ARLINGTON AVENUE BRIDGES REPLACEMENT

Design Review Committee Meeting #6 | September 13, 2022

Park Irrigation

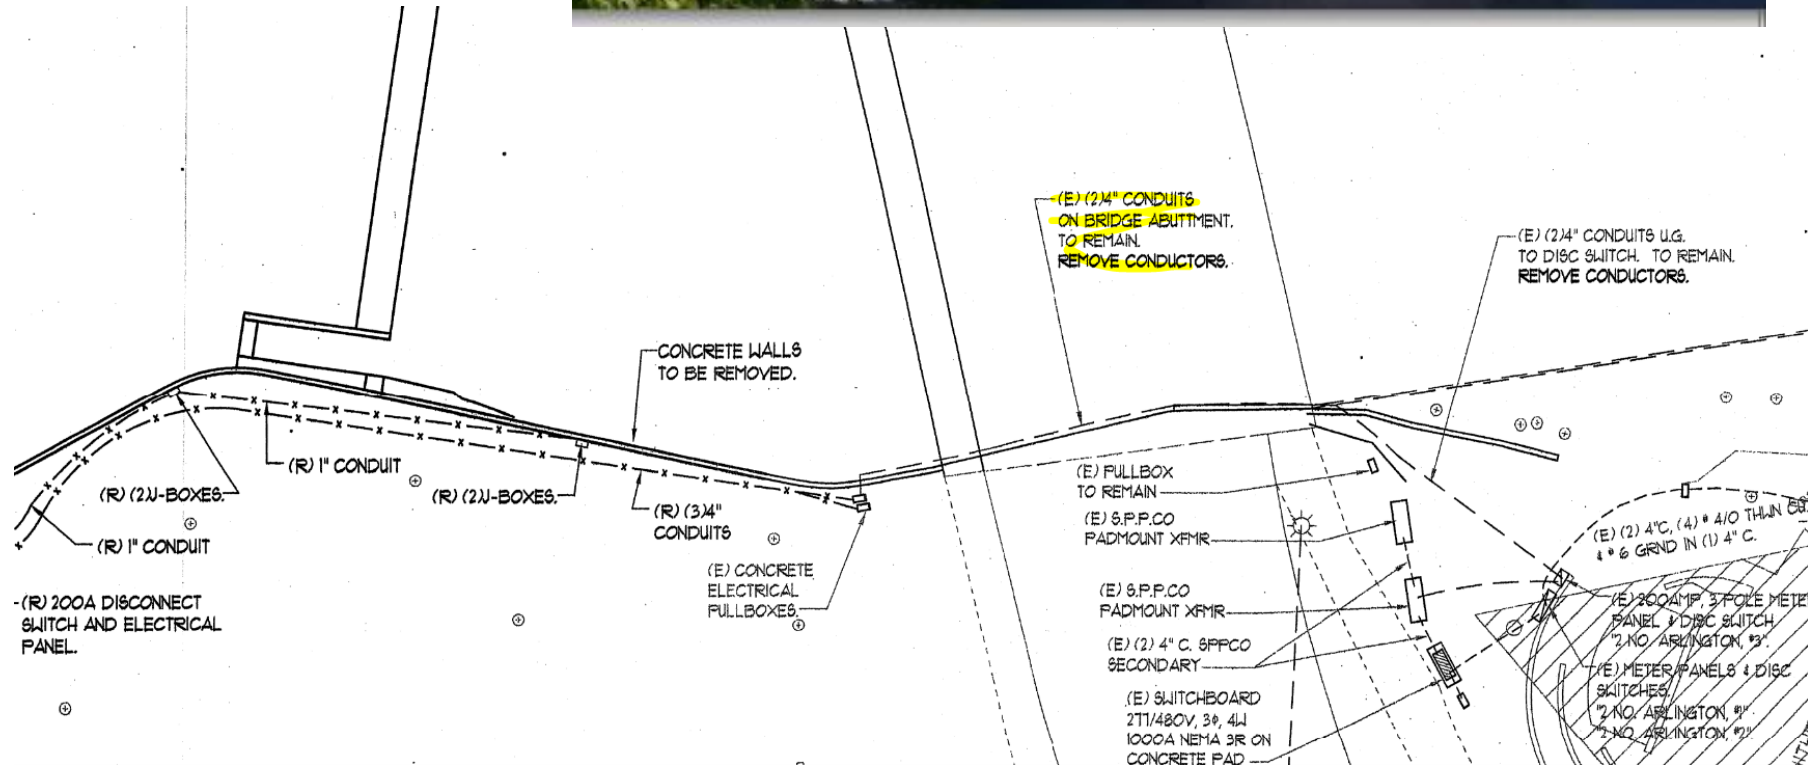
- Across West Face of Bridge - 2 Pipes
- Assume 1 for H₂O and 1 electric for sprinkler system?

Conduit Along Path

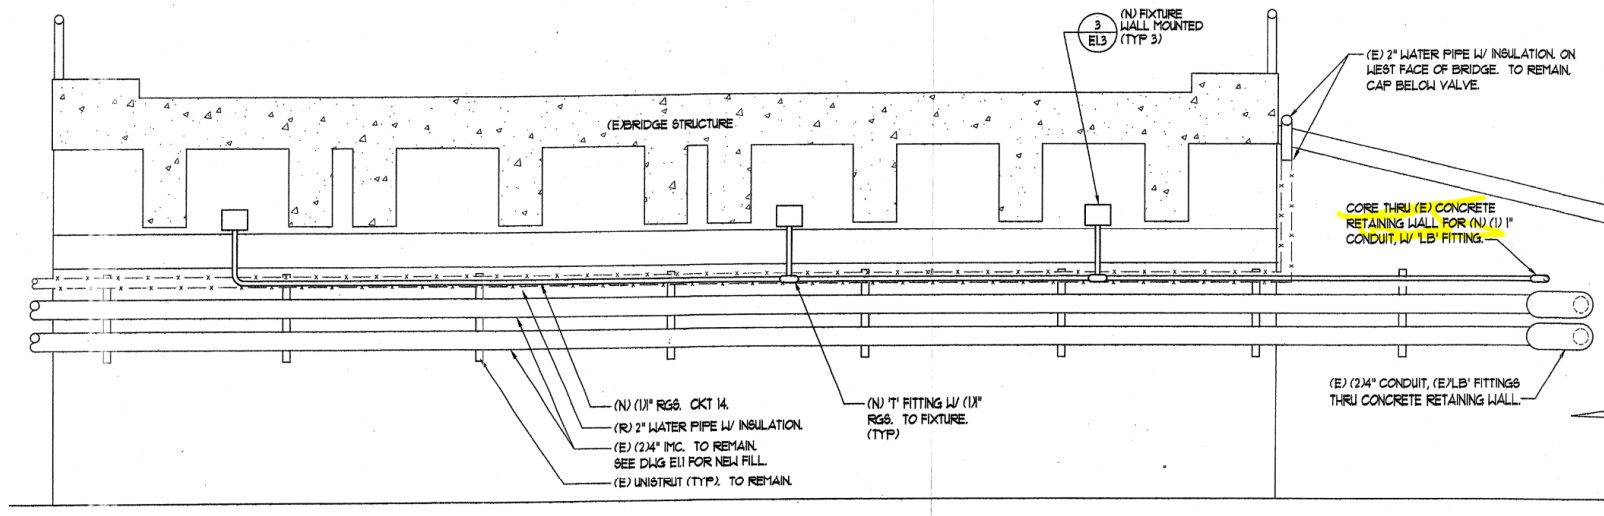
- 2 - 4" Electrical Conduits
- Conductors removed?

- 1 - 1" Electrical Conduit:
Under bridge lighting?

Rectangular Rapid-Flashing Beacon (RRFB)

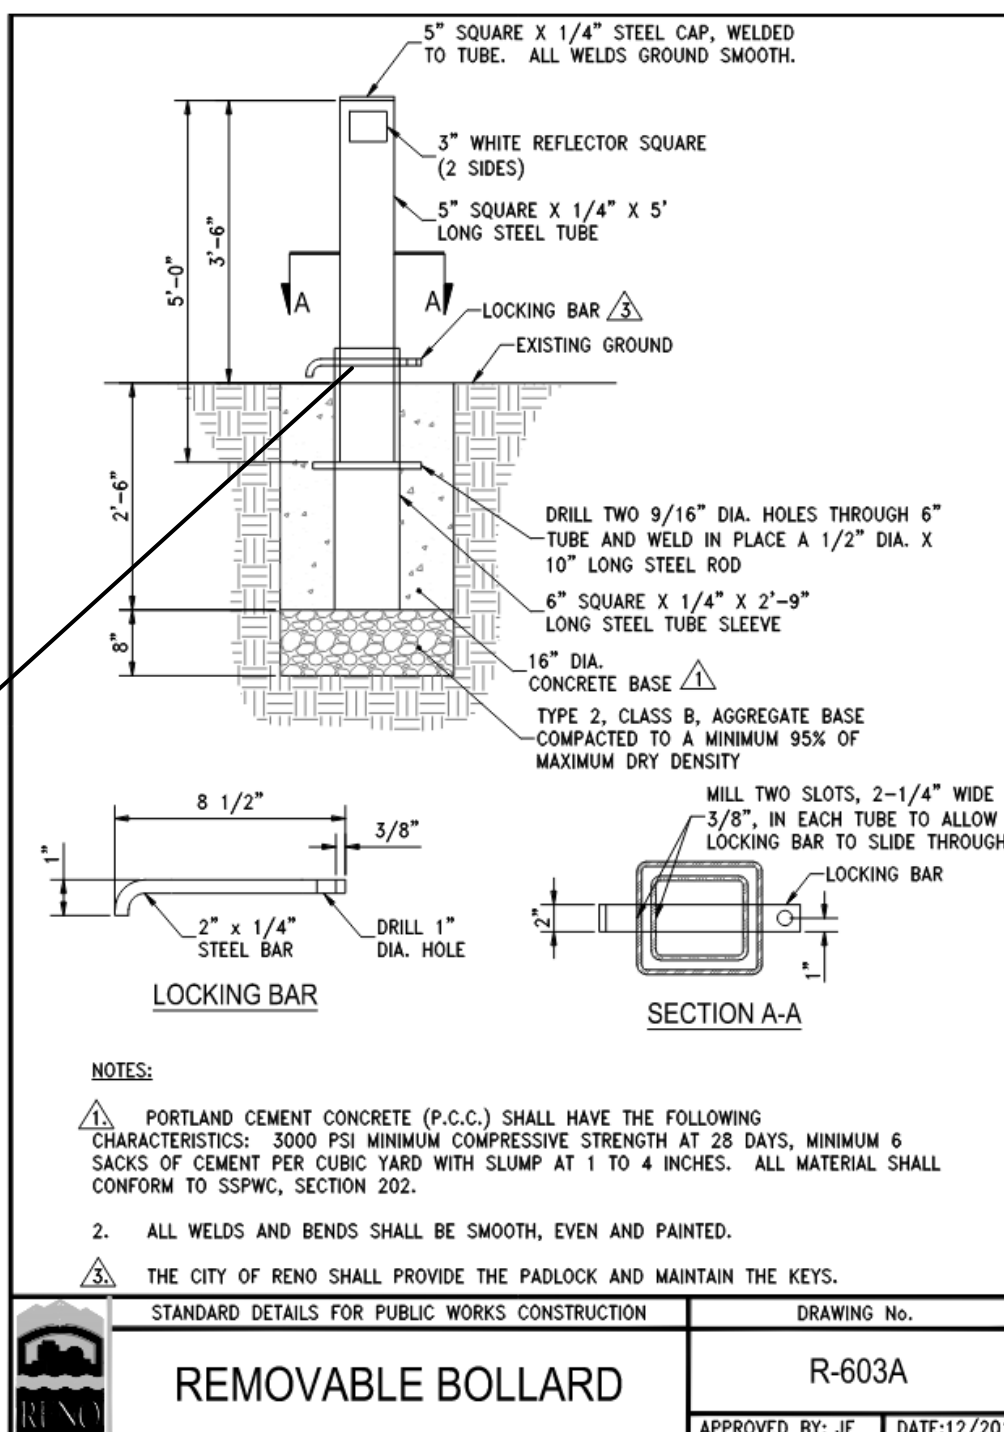
Keep Sidewalk -
Coordination with
moving RRFB

change to RRFB

Bollard Detail

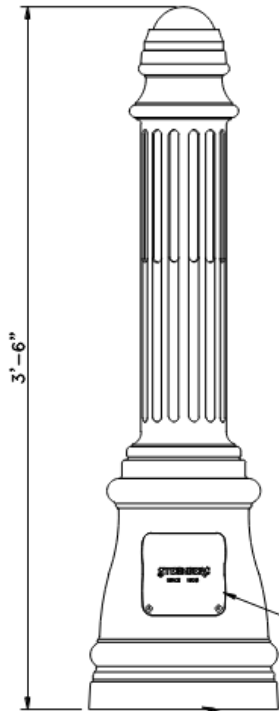
Standard Removable Bollard - Won't work with Raised Tube Sleeve above pavement
